Index, Tall Cabinet Front Serv(F100,F120)
PI457, Issue 6, 17-03-03
Pertronic Industries Ltd

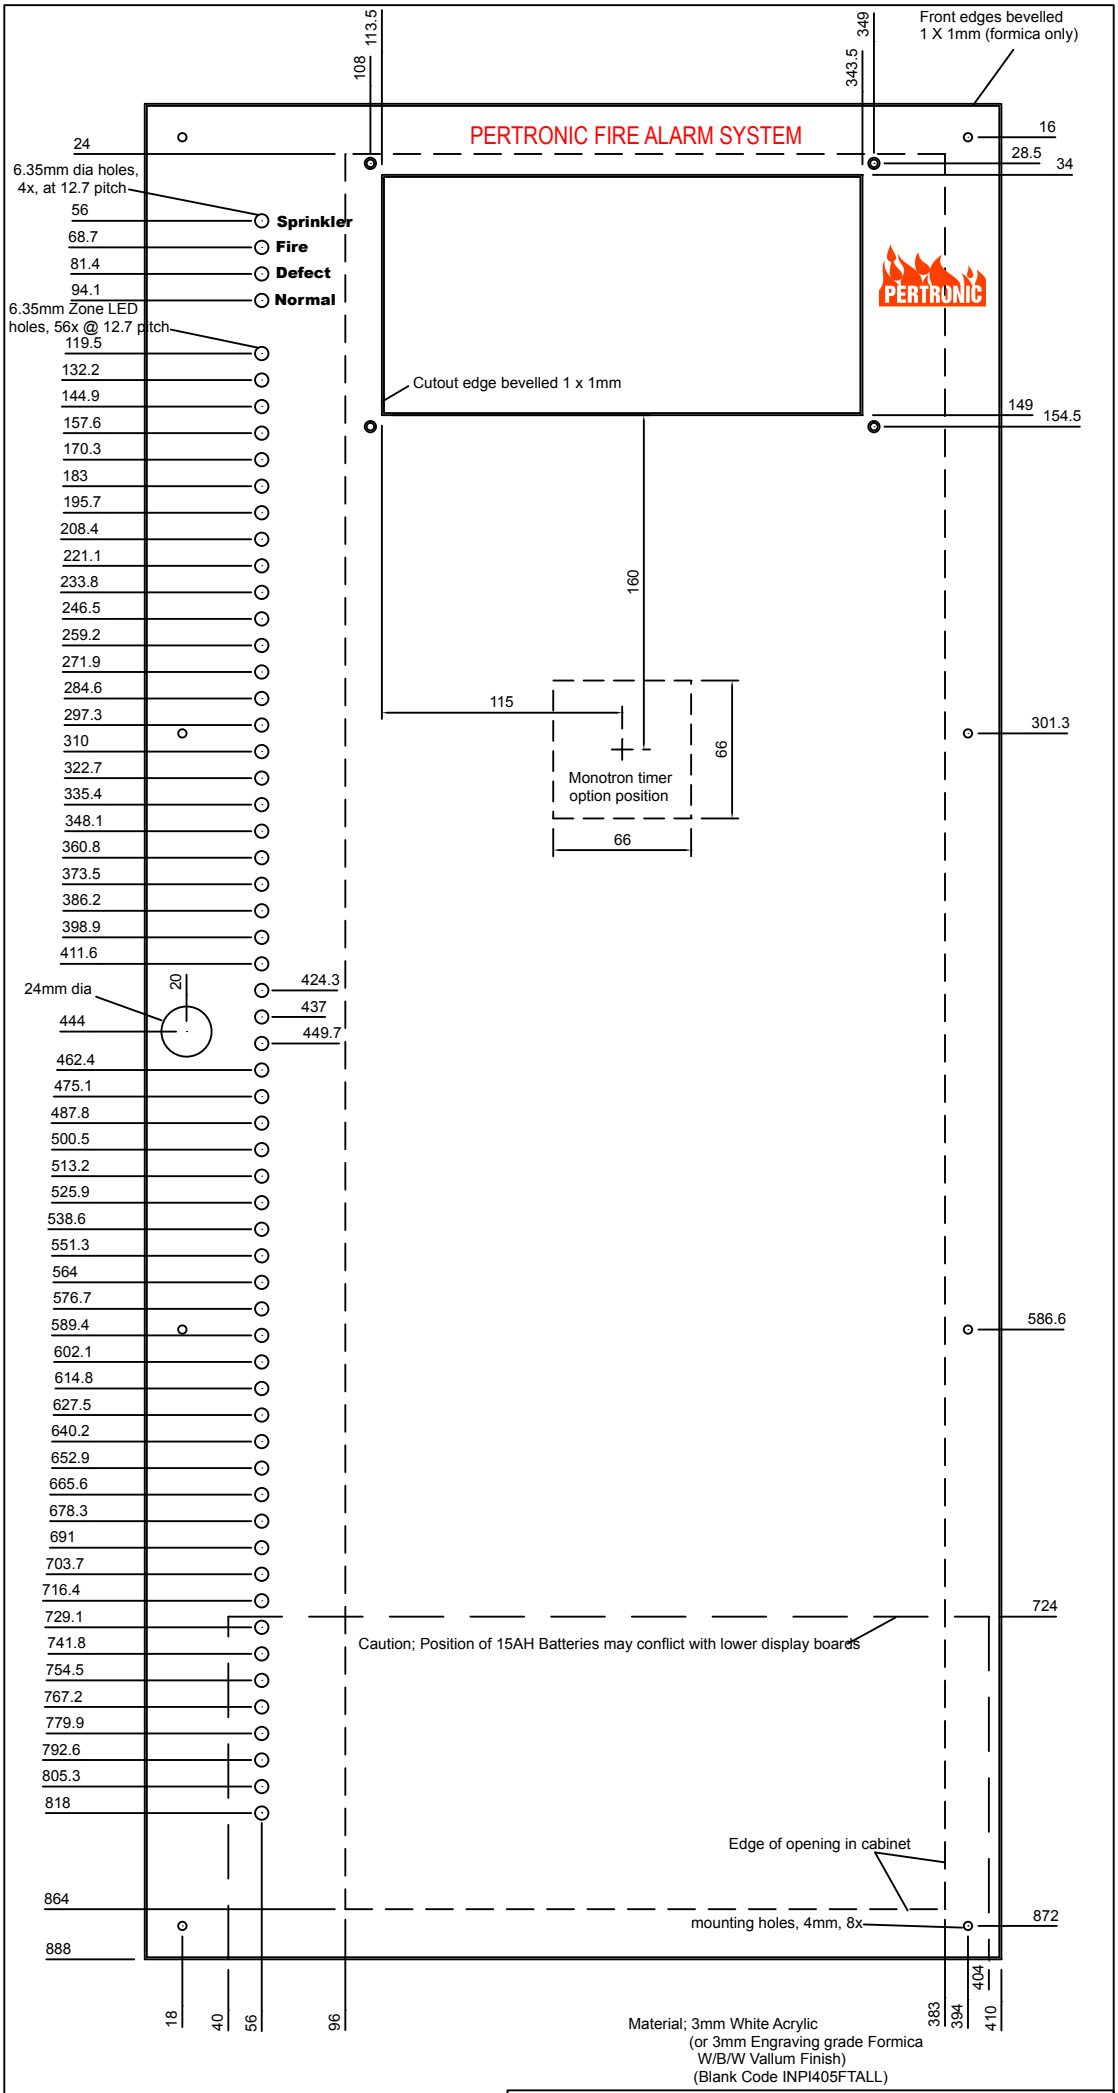
Change Issue 3 to 4; Window & mounting holes moved 7.5mm to right & up 1mm

Change Issue 4 to 5; Height reduced to 888, mounting holes repositioned, LED holes moved 1mm,

Issue 6 changes; countersinking on eight mounting holes deleted & hole size increased to 5mm
